# Pioneer Knitwears (BD) Ltd. (Section-2) (Extension)

23 November 2023

## 2. Observations:

**Observation-6: Lack of design report (Canteen-2).**

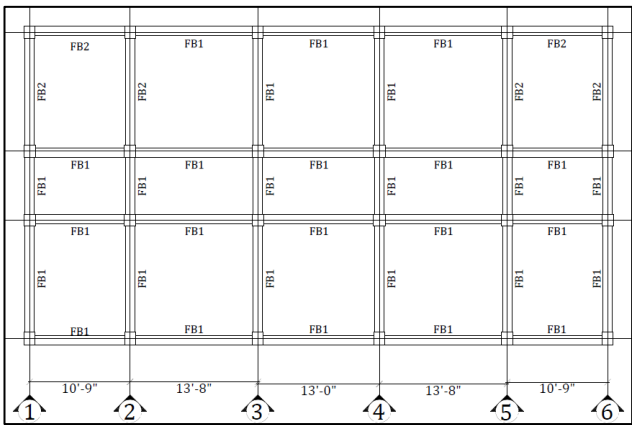
**Description:** As per BNBC, every building or structure designed shall have its design documents prepared following the provision of Section 1.9.1. The design documents shall include as-built drawings and a design report which shall be prepared in compliance with section 1.9.1, part 6 of BNBC.

During inspection, the design report was not available on site. The building engineer is required to prepare a design report based on in-situ material strength & software-based analysis and submit it to RSC for review.

| Serial | Observation                                                               | Action Plan                                                                                                                                                                                                                       | Timeline        |
|--------|---------------------------------------------------------------------------|-----------------------------------------------------------------------------------------------------------------------------------------------------------------------------------------------------------------------------------|-----------------|
| 13     | Lack of design report. (Canteen-2)                                        | Building engineer is required to prepare the design documents including a design report, and a set of structural drawings in compliance with section 1.9.1.1 and section 1.9.1.2, part-6 of BNBC and submit it to RSC for review. | within 6 weeks  |
| 14     | Lack of design report. (Canteen-2)                                        | Carry out remedial works (if any) after review by RSC.                                                                                                                                                                            | within 6 months |

**Observation-12:** Apparently inadequate steel column and connection. (Scrab Godown)

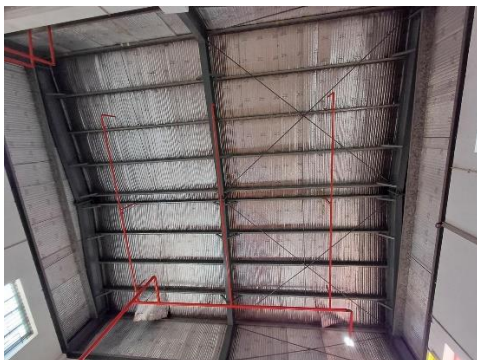
Steel column

Apparently inadequate connection

**Description:** Apparently inadequate steel columns and connections were observed on the lightweight roof of the single-storied Sheds. The building engineer checks the connection adequacy of the lightweight roof against the uplift pressure of the wind.

| 24 | Apparently inadequate steel columns and connections. (Scrab Godown) | The building engineer is required to check member adequacy and the connection of the steel roof for the uplift pressure of the wind. | within 6 weeks  |
| 25 | Apparently inadequate steel columns and connections. (Scrab Godown) | Carry out remediation work if required.                                                                                              | within 6 months |
